## AIRWORTHINESS DIRECTIVE

### Piper PA-30 & 39 (Twin Comanche) Series Aeroplanes

**AD/PA-30/34  
Amdt 1**

### Main Landing Gear Side Brace Stud

Figure 1

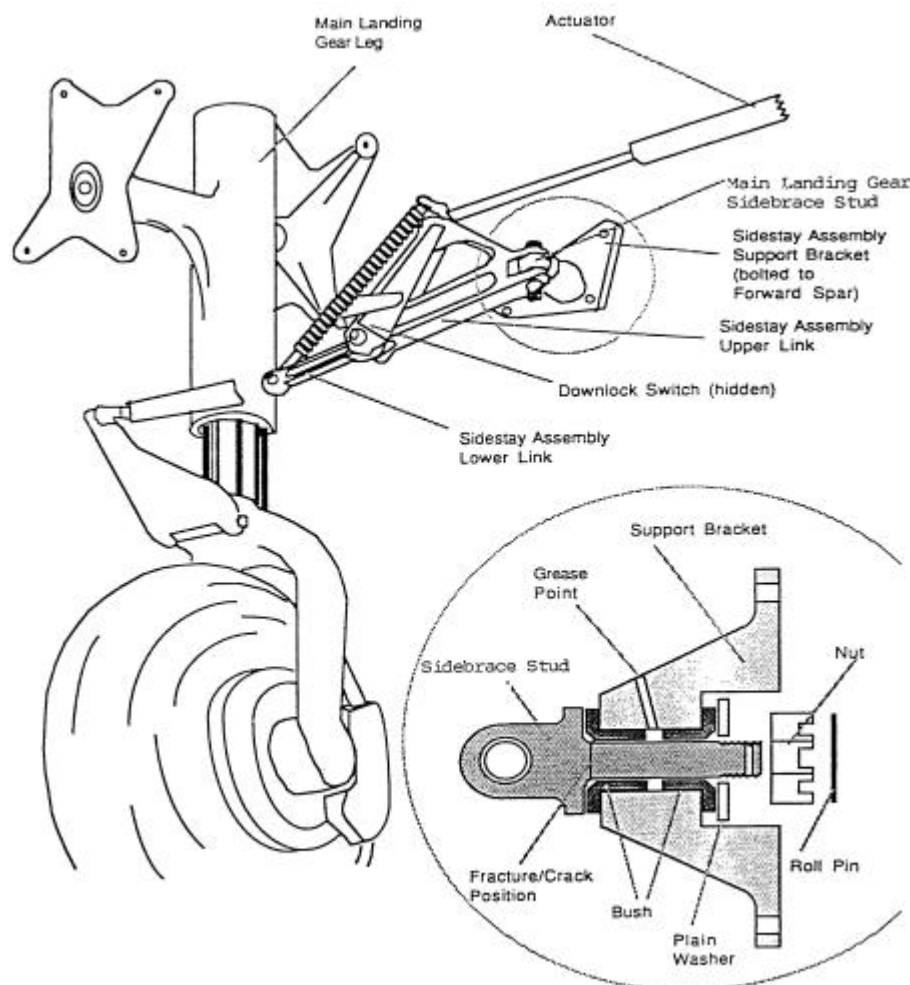
Requirement: Remove both the left and right main gear side brace studs from the aircraft in accordance with the instructions contained in the Landing Gear section of the maintenance manual, and inspect each main gear side brace stud for cracks using fluorescent penetrant or magnetic particle inspection methods. Figure 1 of this Directive depicts the area where the sidebrace stud is to be inspected.

For any main gear side brace stud found cracked, replace the cracked stud with an approved serviceable part in accordance with the instructions contained in the Landing Gear section of the applicable maintenance manual.
